Subject: Arkansas Nuclear One - Unit 2
Docket No. 50-368
License No. NPF-6
Containment Cooling Response Time Technical Specification Change Request -
Additional Information (TAC No. M92066)

RESPONSE TO NRC QUESTIONS

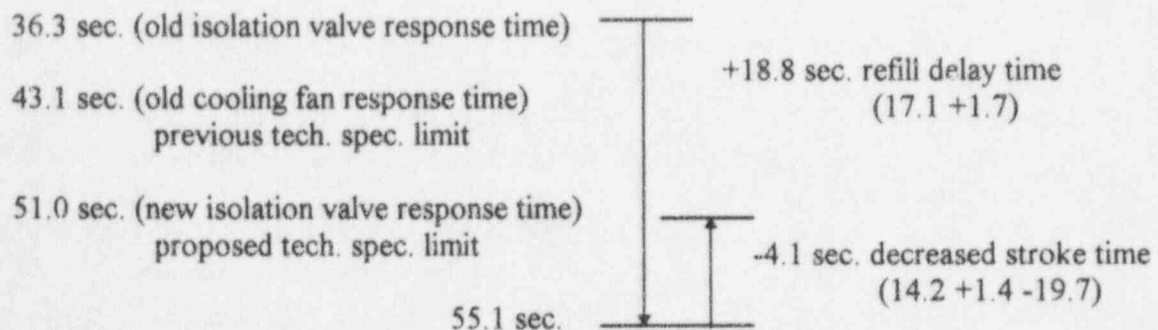
3. The licensee's analysis uses 17.1 seconds for the delay time to maintain the containment cooling service water valves closed until the service water pumps start and the slow refill has occurred, and the delay time for 10% opening of the containment cooling service water inlet valve and full opening of the outlet valve are 1.4 seconds and 14.2 seconds, respectively. The staff requires additional explanation of specifically how these delay times were arrived at. Explain why the additional 17.1 second delay time only results in an overall change of 7.9 seconds in the TS requirement. For comparison, the staff also requires a breakdown of the delay times associated with the 28.1 seconds that is referenced for the case when off-site power is available.

The response time of the containment cooling isolation valves before the modification was made contained the following component response times:

1.6 sec.	ESFAS instrument response time
15.0 sec.	Emergency diesel start time
19.7 sec.	Isolation valve stroke time
36.3 sec.	Total system response time

Therefore, the combined effect of the change in the limiting component response time, the added delay times, and the decreased valve stroke time is an increase in system response time of 7.9 seconds.
